Sheet: /PRANCHA V: PLACA CONTROLE DA MEMÓRIA/
File: FCM-7.kicad_sch

Title:	
Size: A2	Date: 2 aug 2016
KiCad E.D.A. 9.0.2	Rev: 06: 7/18

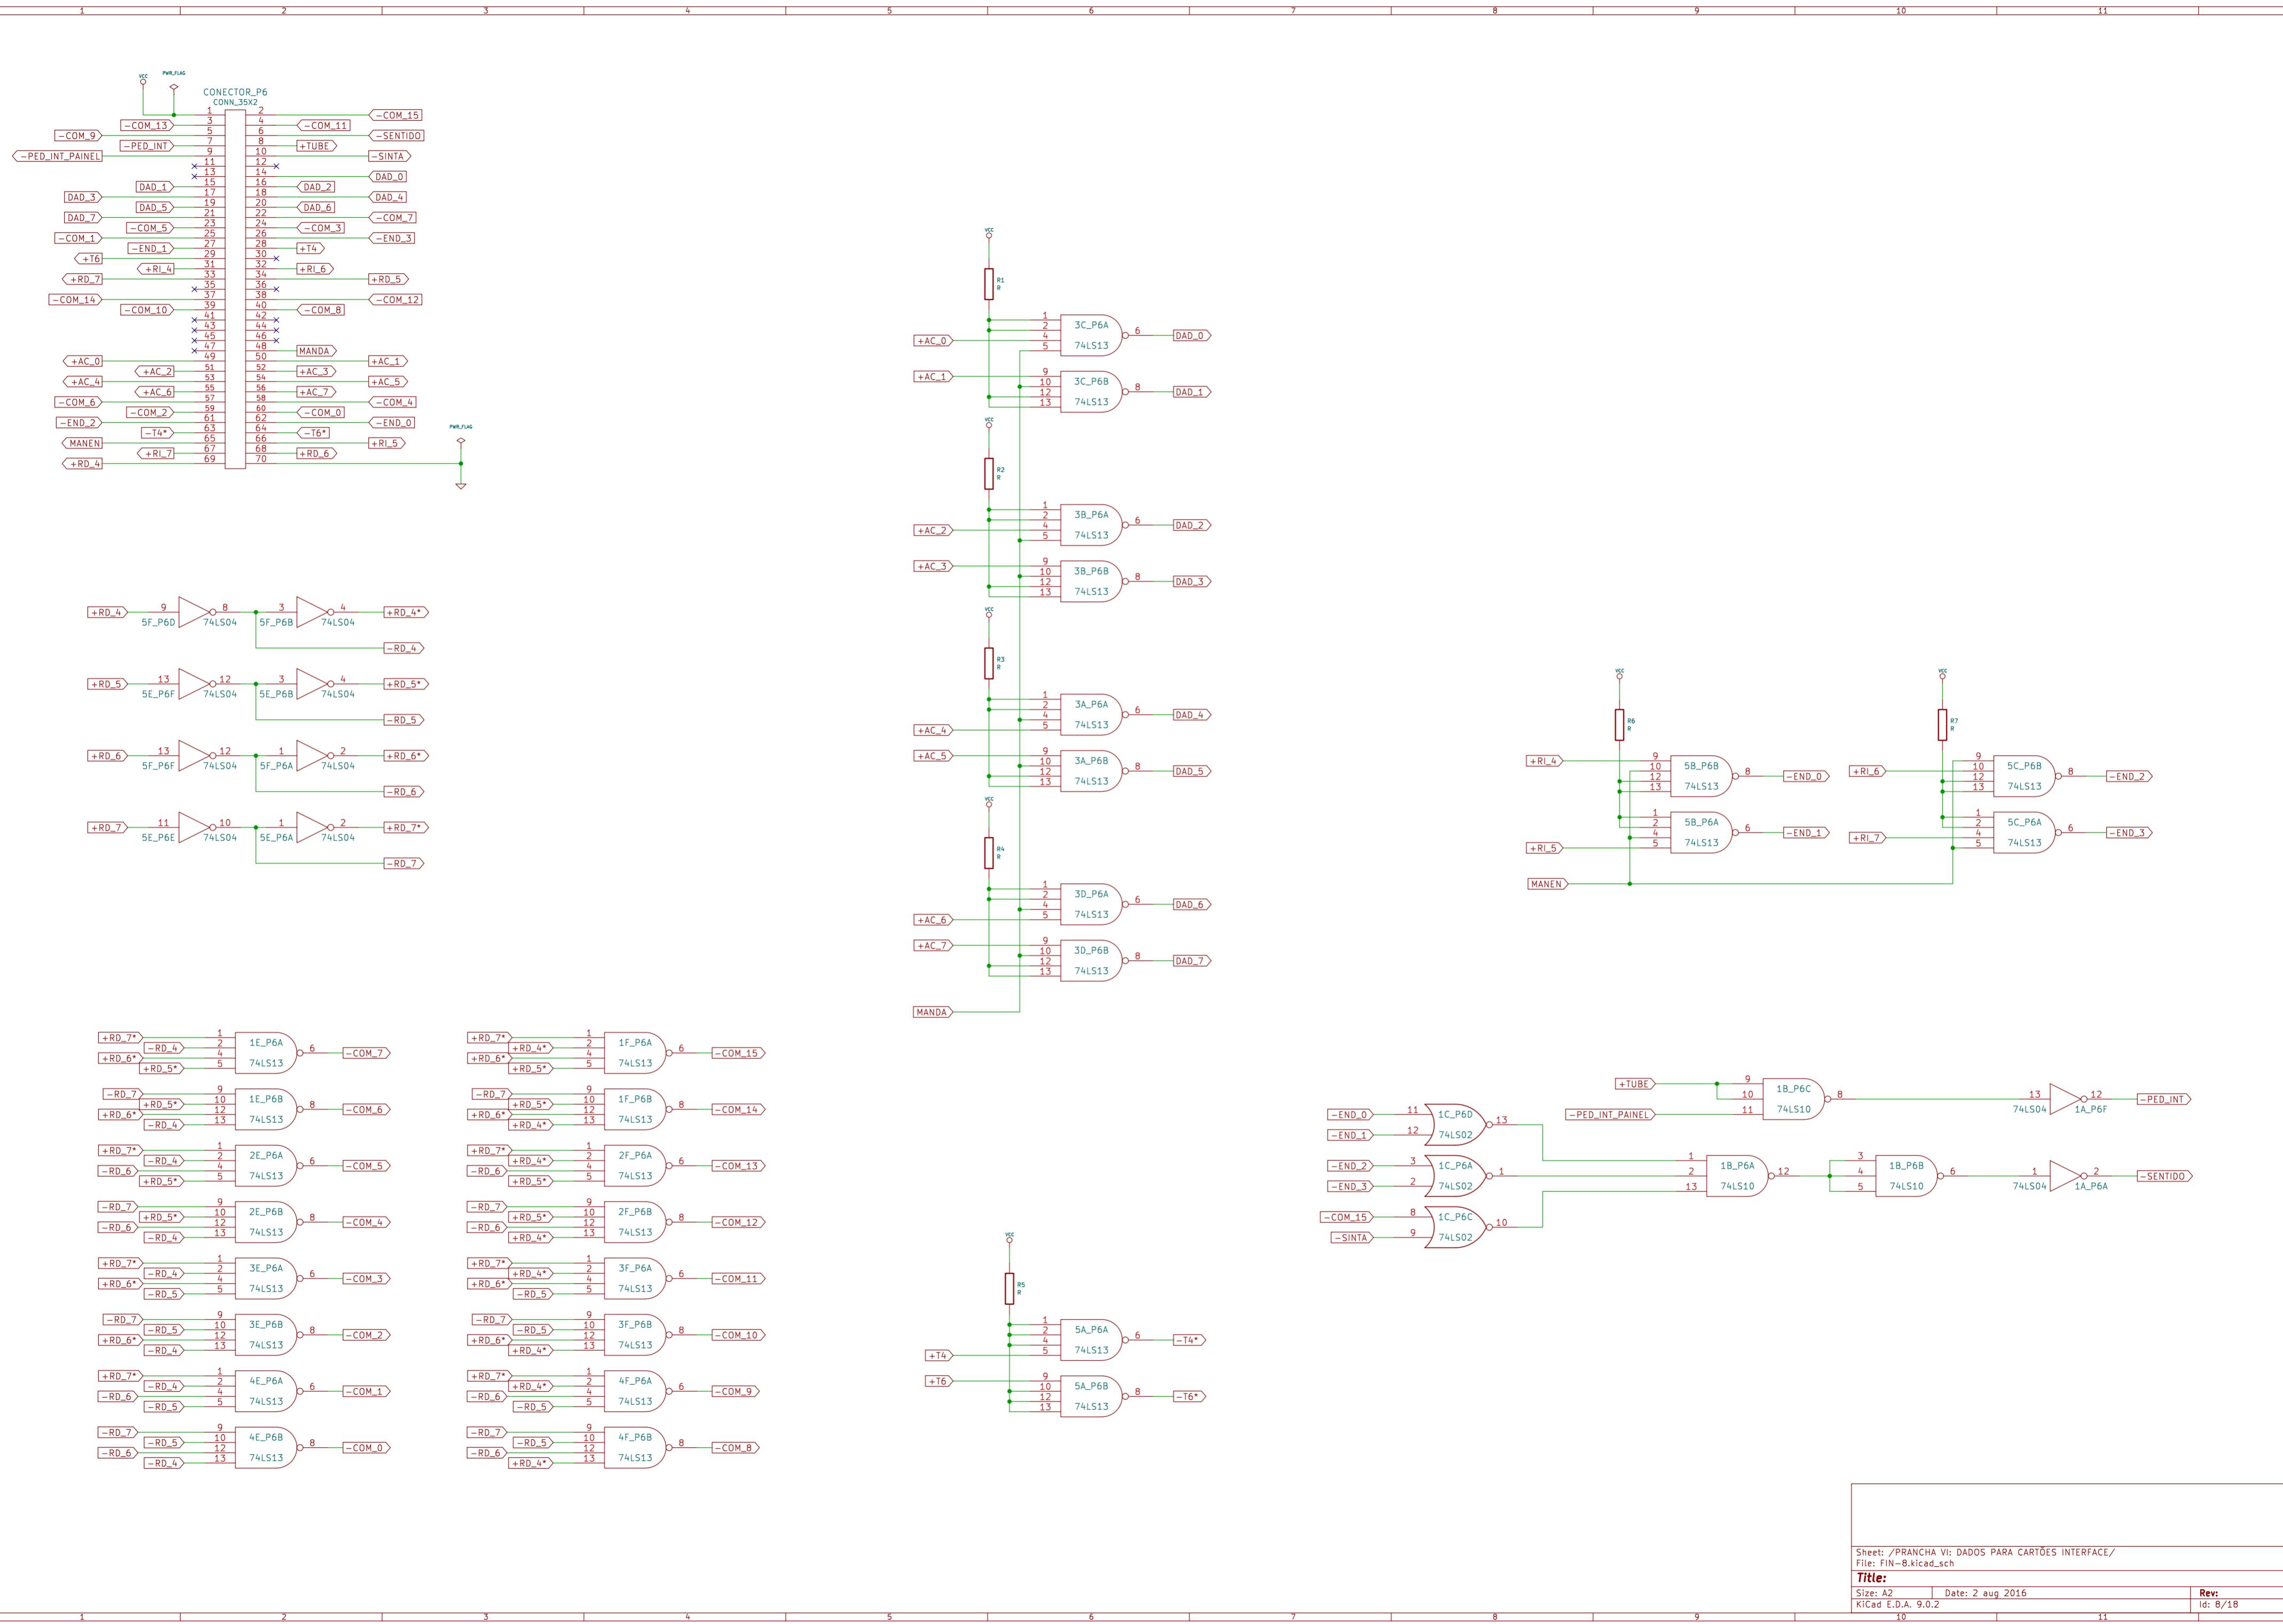
(*) Isso aparenta estar errado.
Há ainda 2 unidades disponíveis na pastilha 4B.
Por que não usa-se-as aqui?
